Mark Lawler Architects

**RE: DA/419/2018 - MIXED USE DEVELOPMENT
114-120 CARY ST, 1, 2, 3, 5 BATH STREET, 3 ARNOTT AVENUE
TORONTO NSW**

Please find following our response to the items listed in Council letter dated 6th June, 2018 and the SEPP65 Design Review Panel's recommendations from the 13th June, 2018 meeting.

Figure 5 – 3D Height Plane Renders

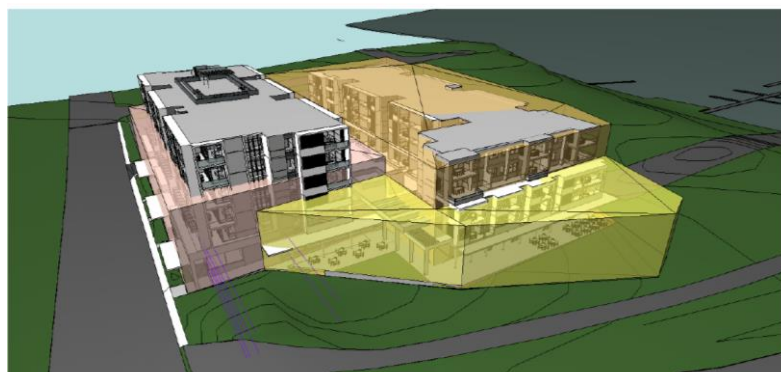
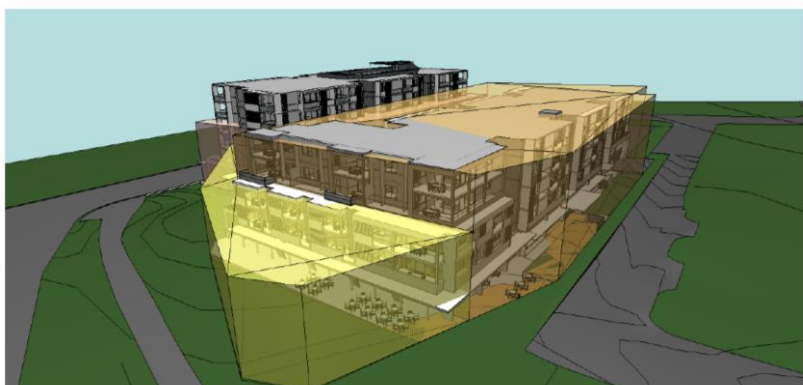
The Clause 4.6 Variation Request includes 3D images (Fig.5 on pg4 of the Request) depicting the LEP height limits as a transparent building envelope. These images are also included separately in larger format for clearer indication.

Whilst indicating the Cary St building projecting above the envelope, the images also indicates the significant space *within* the building envelope that is not occupied by built form, particularly the central open communal space and the setting back from the public reserve & former rail line at the south.

McDONALDS SITE DEVELOPMENT POTENTIAL

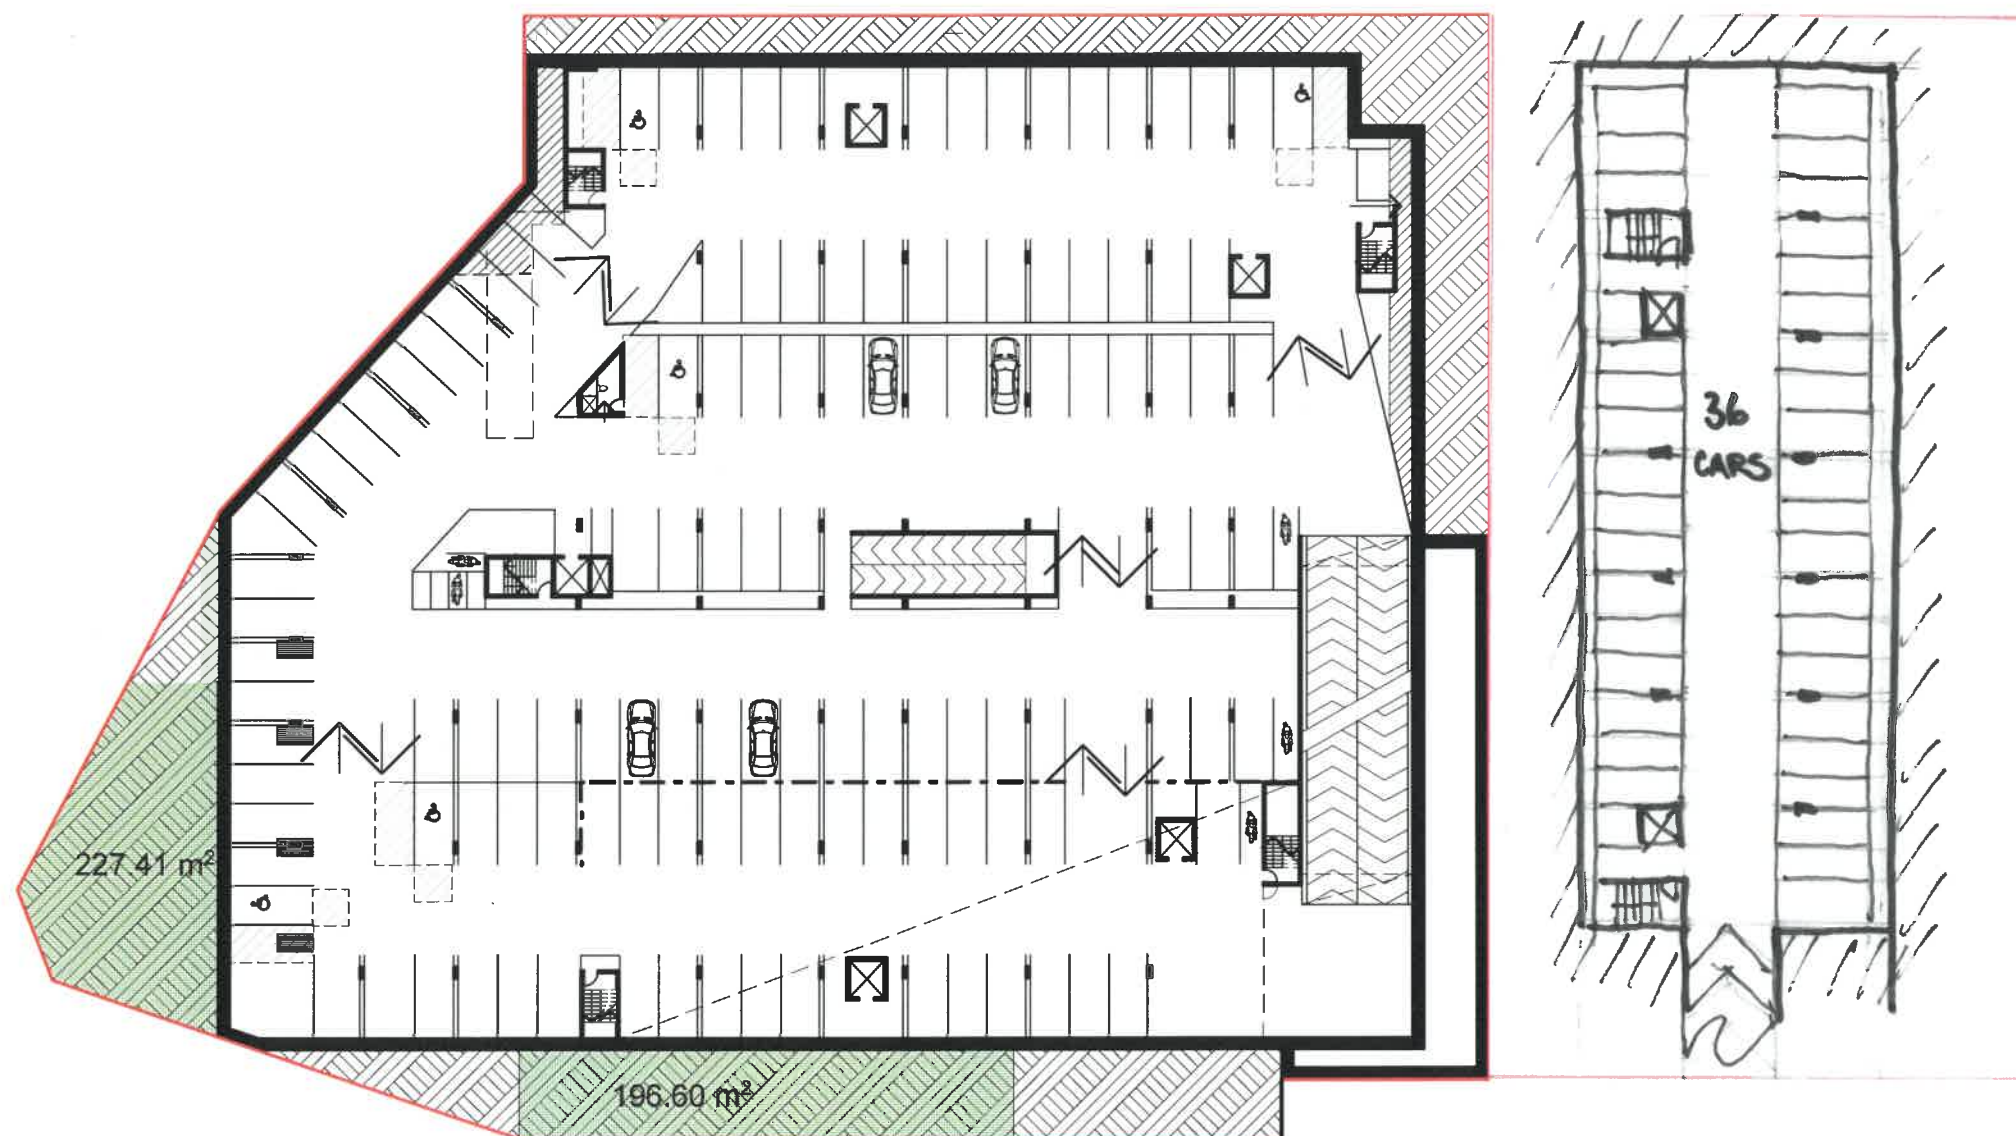
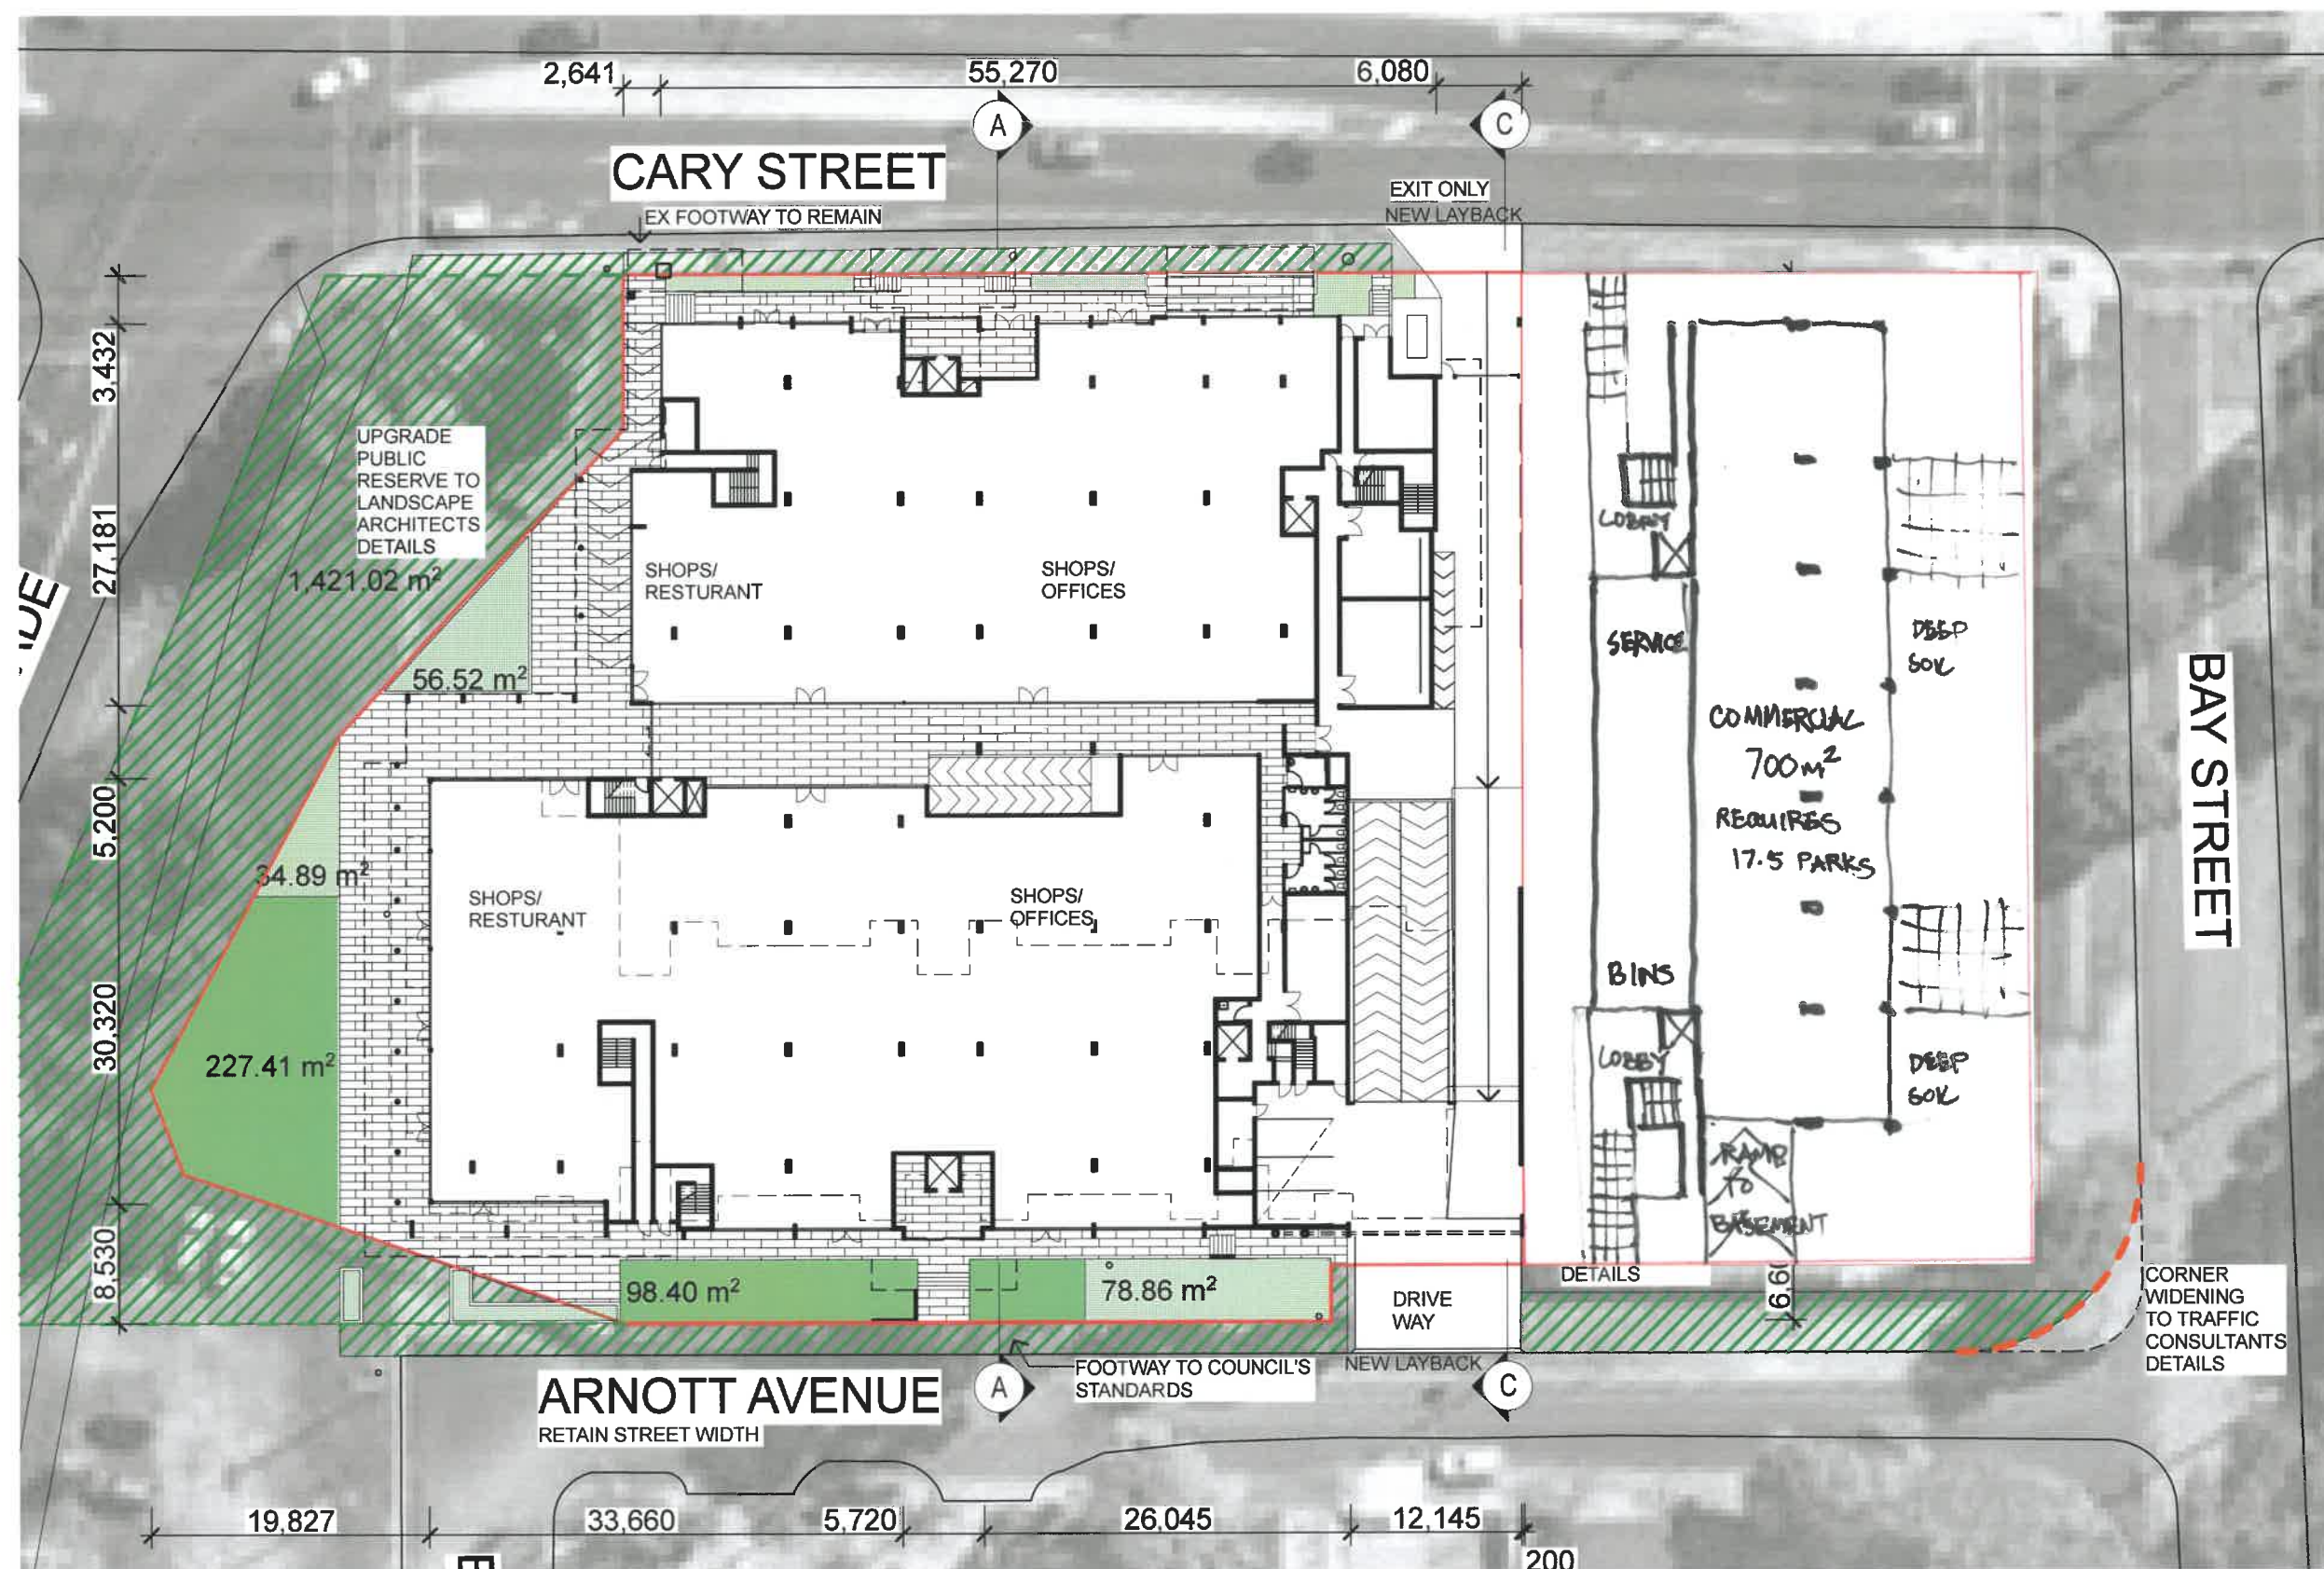
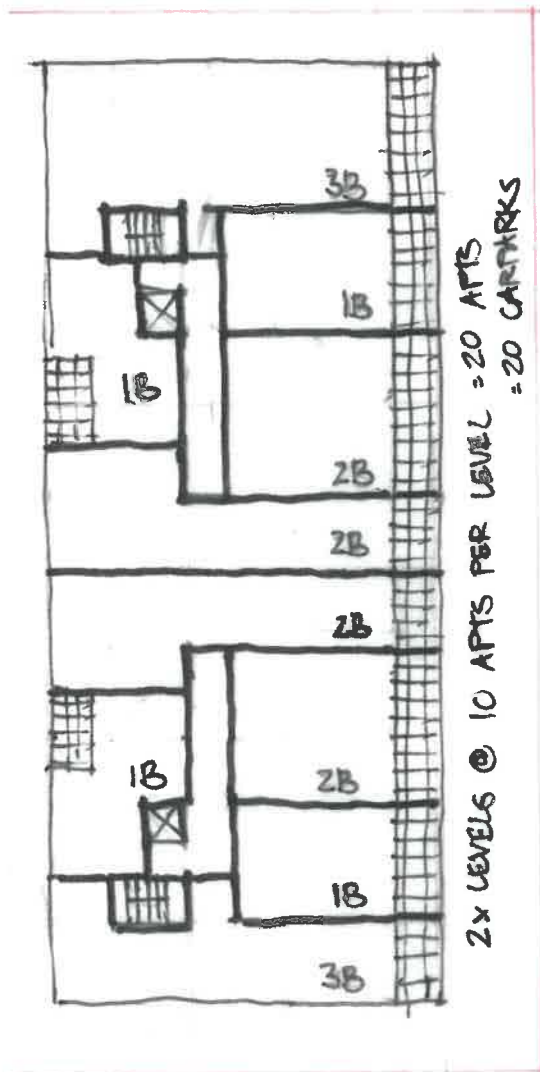
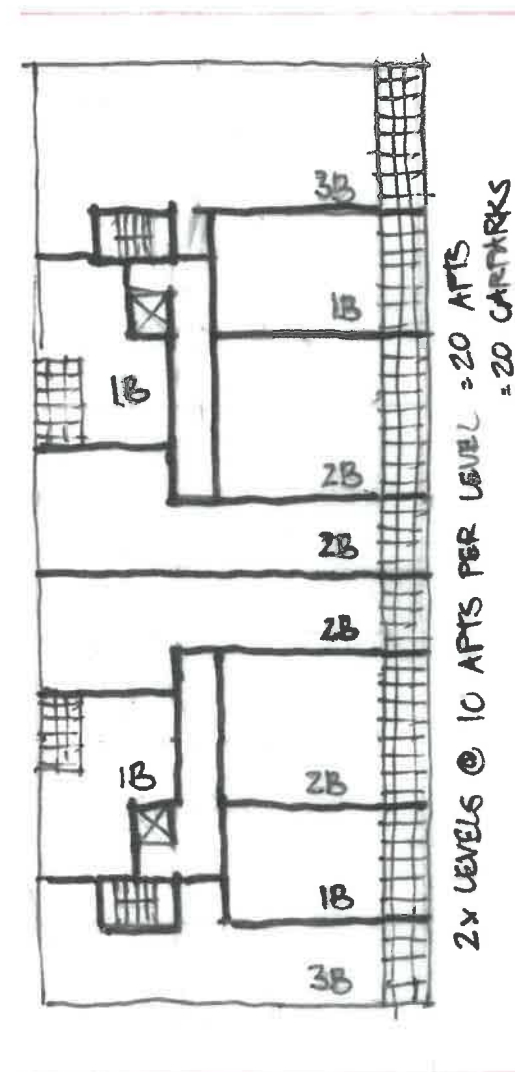
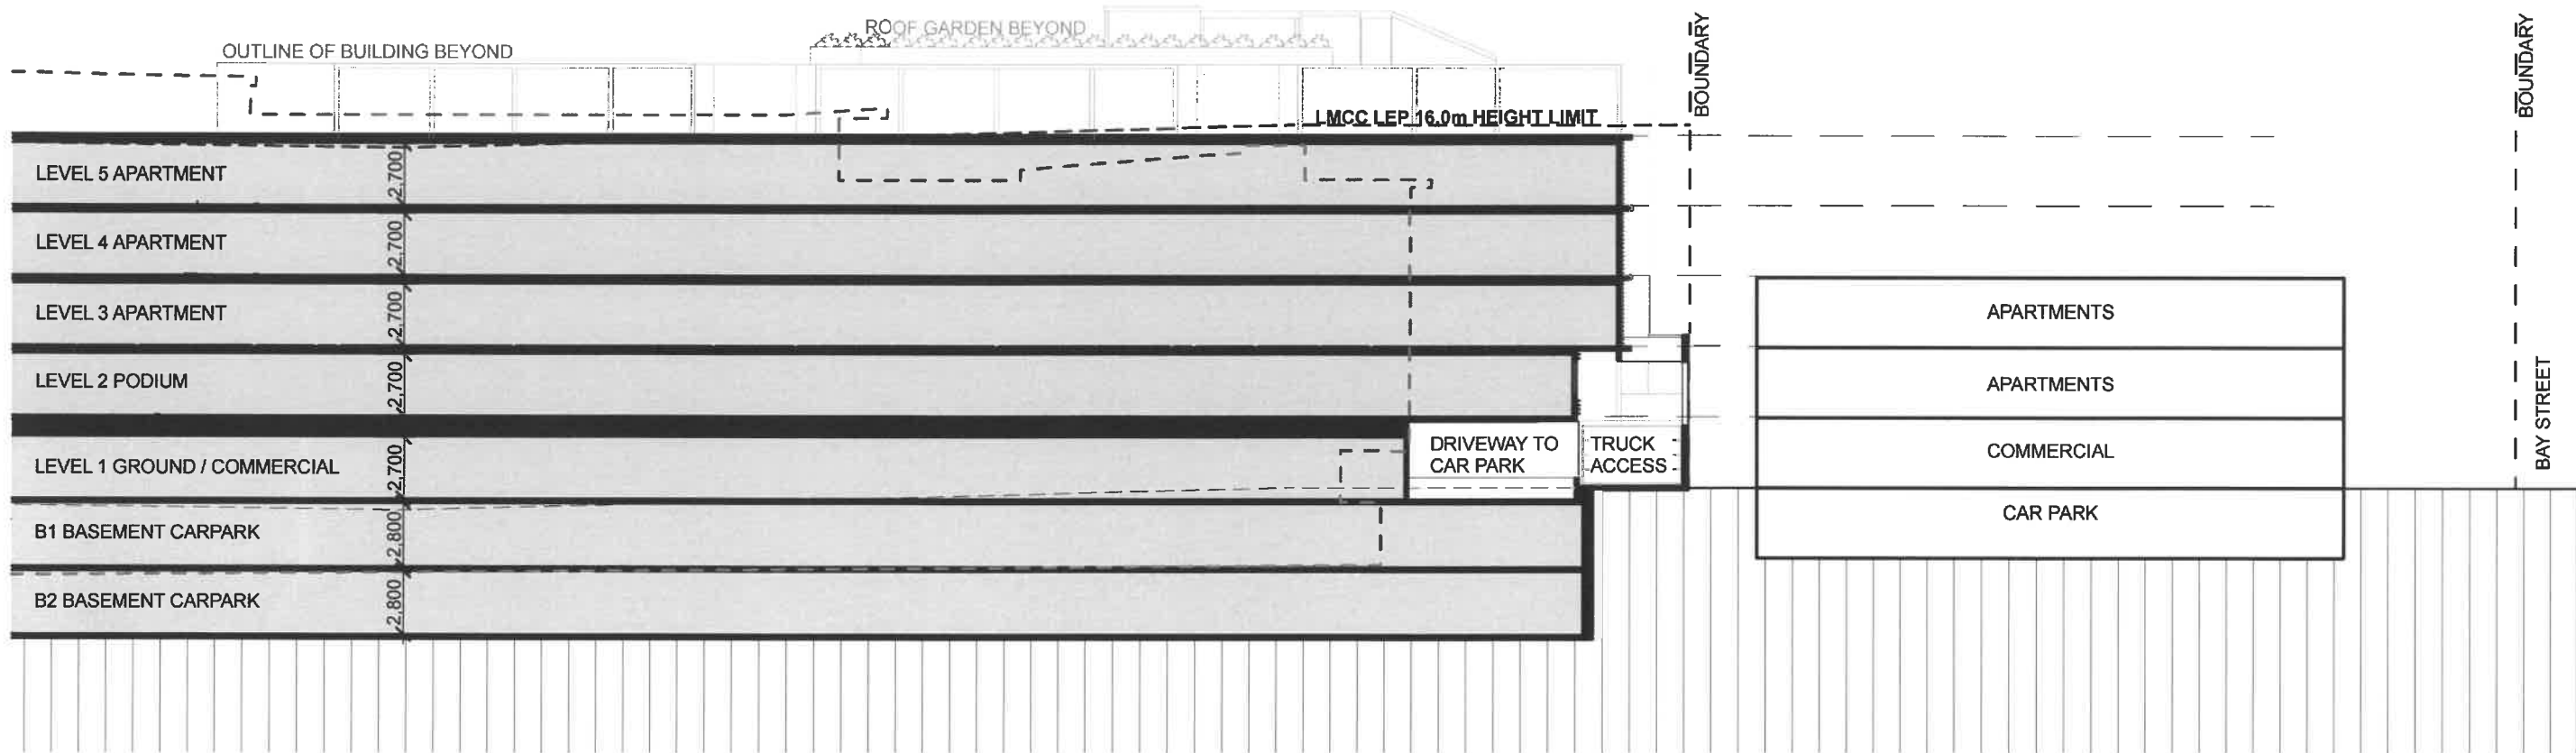
It would be appropriate for the applicant to provide analysis to demonstrate how the McDonalds site may be developed in the form of at least a complying development under the current LEP controls, but also contemplating development applying similar principles to those proposed on the subject site.

The McDonalds site has been reviewed for a mixed use development potential. Refer attached sketch plans. The site's dimensions and carpark accommodation restricts this site to maximum 3 levels above ground. It cannot support 4 – 5 levels due to the parking limitations. Building and apartment orientation would position Living areas towards the North facing Bay St away from our proposal with minimal Living and bedrooms towards the south facing our proposal. This arrangement minimises Living areas directly facing each other between the sites, notwithstanding the use of privacy screens anyway.
